NOTICE OF AWARD

IFB #019-0-2025/SB

Description of Work/Products to be furnished: **Woodside High School Main Distribution
Switchboard Replacement**

Woodside High School Main Distribution Switchboards Replacement

PV GROUNDING ELECTRODE CONDUCTORS

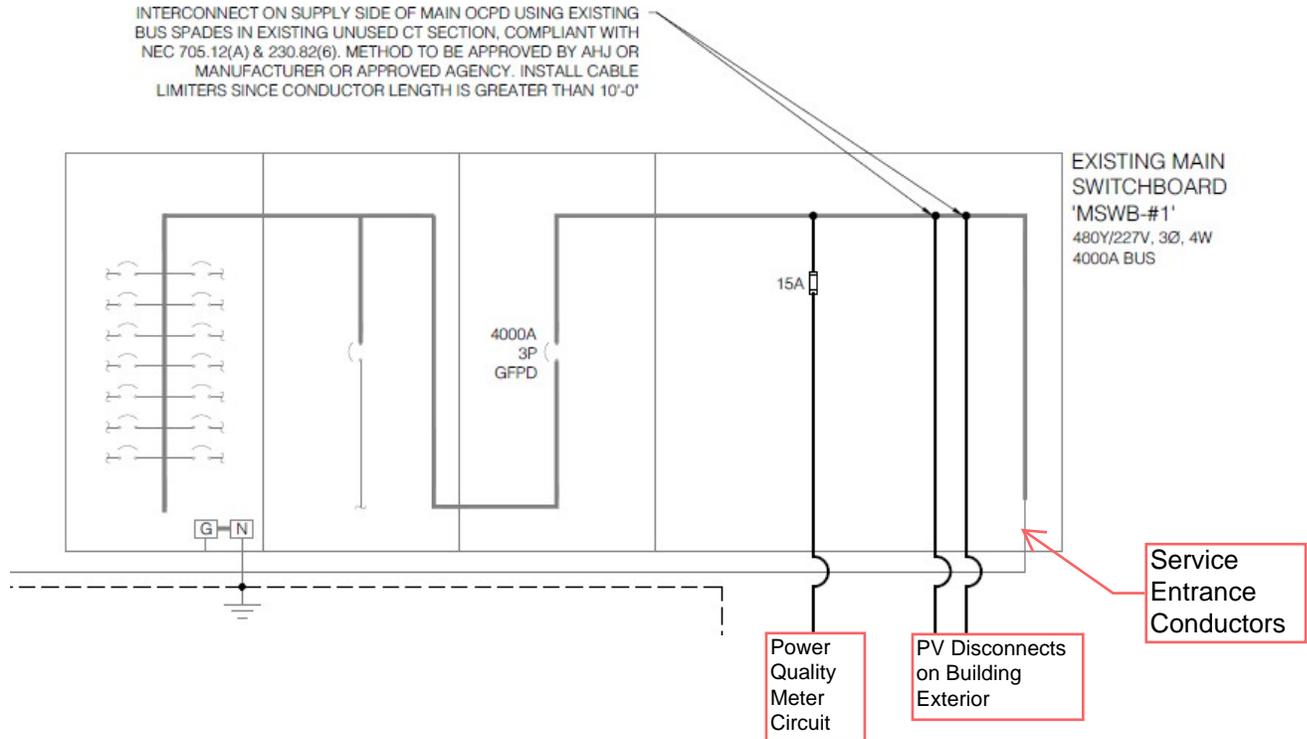
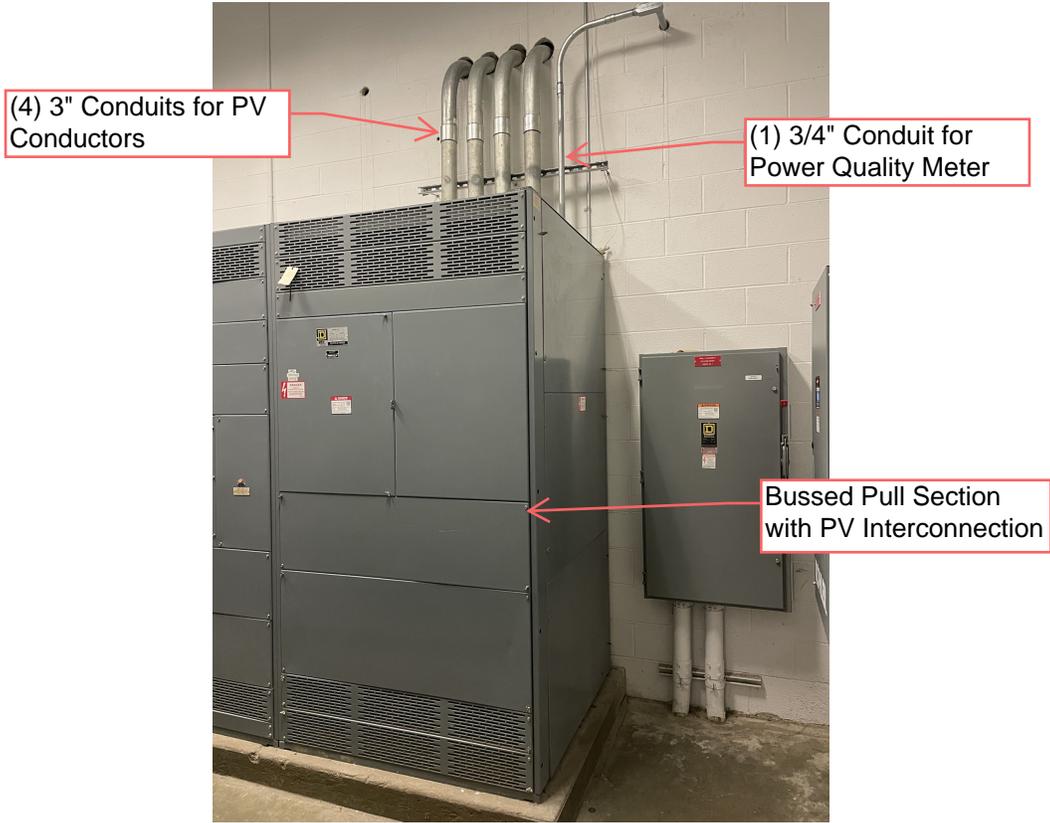
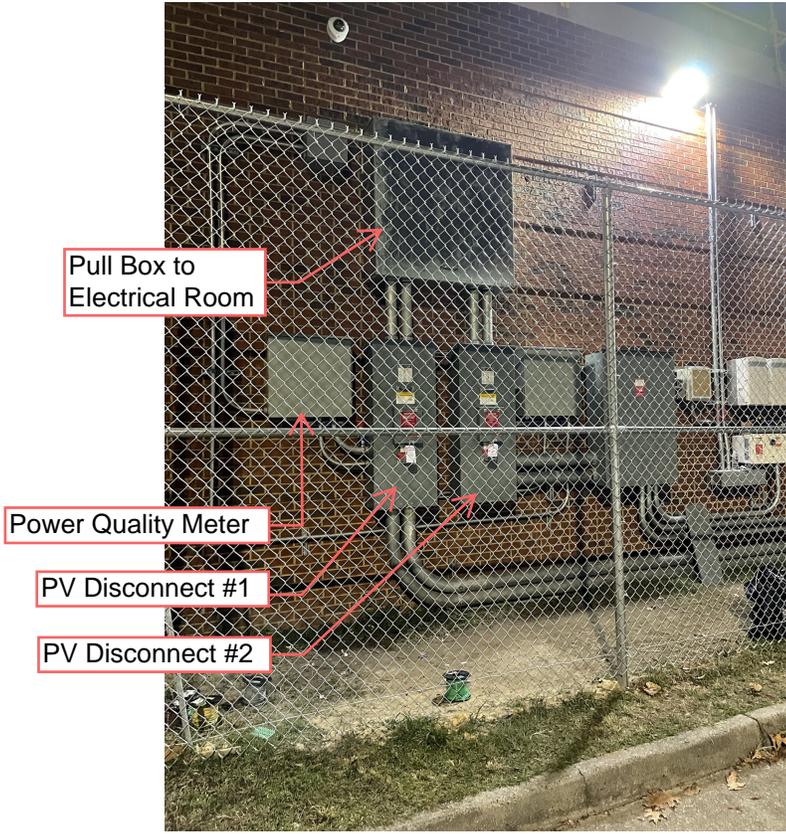
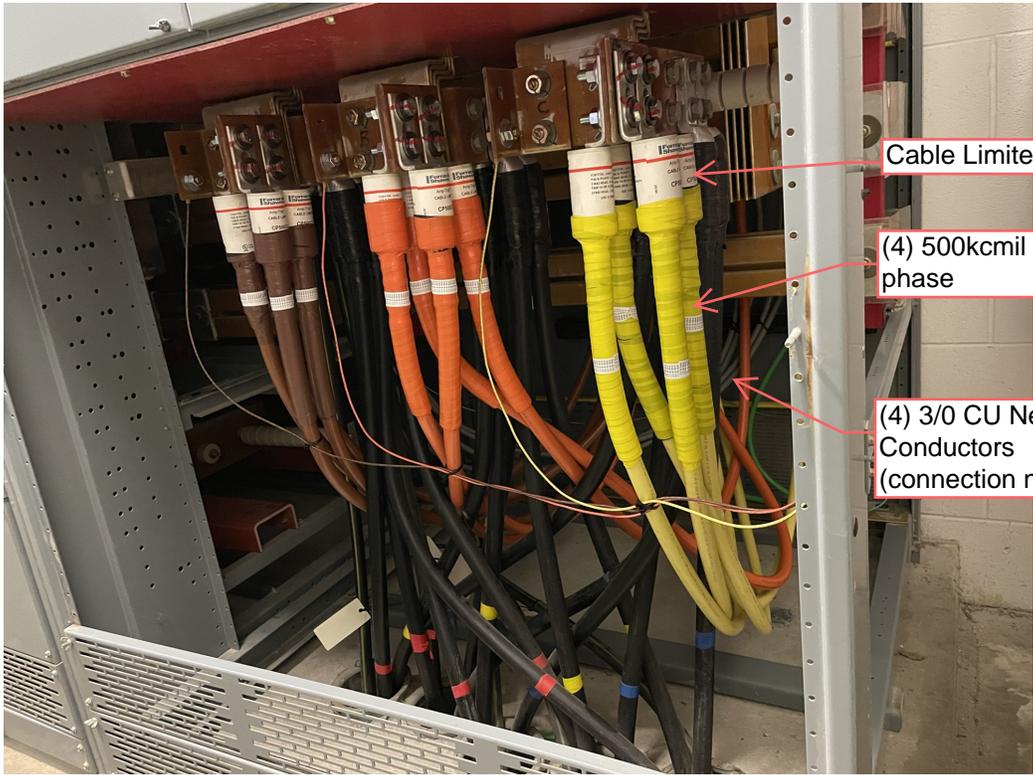
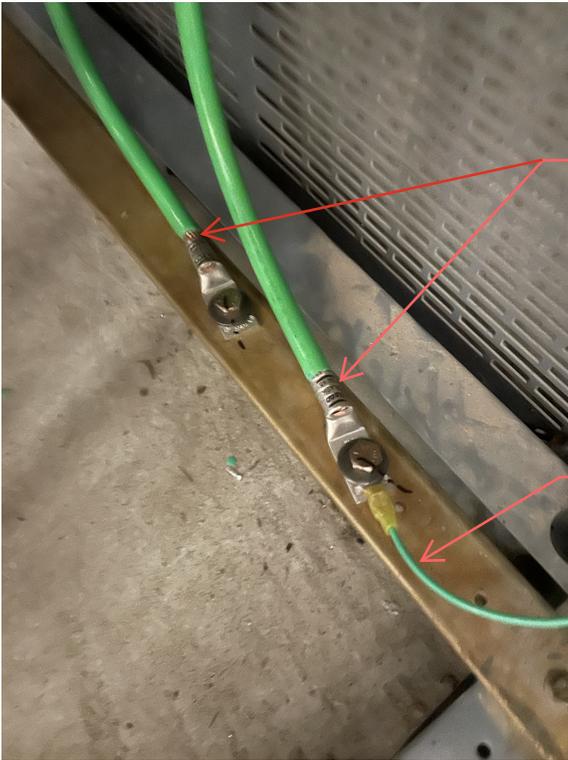
Question 12 Drawing E0.1 note #4 under the switchboard section stated, "provide bus bar extensions on the line side of the CT compartment for the PV system" From taking with the switchboard manufactures this would have to be completed in the field, the switchboard would not be manufactured this way. If the connection is on the line side of the CT cabinet is the intent to put the stored electricity back on the grid? **Answer:** The contractor shall refer to the specifications provided by Sun Tribe for the required number of lugs needed for the termination of the photovoltaic system. The required termination quantity and size shall be coordinated with the distribution manufacturer so that Sun Tribe can terminate the bussing.

- (4) 3/0 CU THWN-2 conductors
- Terminated with UL-listed compression lugs (2-hole NEMA pattern)
- Connected to the neutral bus using grade 5 hardware with flat washers
- Conductors shall be reused and re-terminated in the new switchboard as shown in the existing configuration

- (2) 2/0 CU THWN-2 conductors
 - Terminated to the ground bus using UL-listed compression lugs with 1-hole tongue
 - Each secured with a flat washer and torque-marked bolt to ensure proper mechanical and electrical contact
-

- Conductors shall be reused and re-terminated in the new switchboard as shown in the existing configuration

- Phase Conductors - (3) #12 CU THWN-2
- Neutral Conductor - (1) #12 CU THWN-2
- EGC - (1) #12 CU THWN-2
- Fusing:
 - (3) Class CC, 600V, 15A time-delay fuses
 - DIN-rail-mounted touch-safe fuse holders in switchboard bus section
- Wiring:
 - Reuse existing #12 CU THWN-2 conductors
 - Provide terminal blocks or wire lugs as needed to support termination of control and voltage sensing conductors within the switchboard interior
- These components support the voltage sensing and operational integrity of the revenue-grade Power Quality Meter and must be fully replicated in the new switchboard assembly.

(4) 500kcmil CU per phase

(4) 3/0 CU Neutral Conductors (connection not shown)
